SPRI
Codes & Standards
Crowne Plaza at the Crossings
Warwick, RI
July 12, 2022
8:00 a.m.

SPRI
Rooftop Attachments
Crowne Plaza at the Crossings
Warwick, RI
July 12, 2022
12:45 p.m.

Rooftop Equipment Attachment
by
SPRI Trask Group on Rooftop Attachment with Anchors
and
Curtis L. Liscum. RRC. RRO

Figure RE1.1

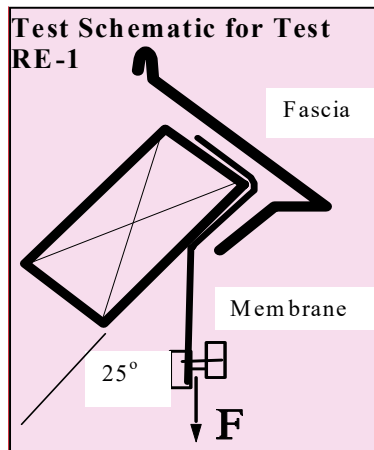
Commented [BL8]: This detail could be drawn better, and is it even needed? RE1.2 shows the same thing.
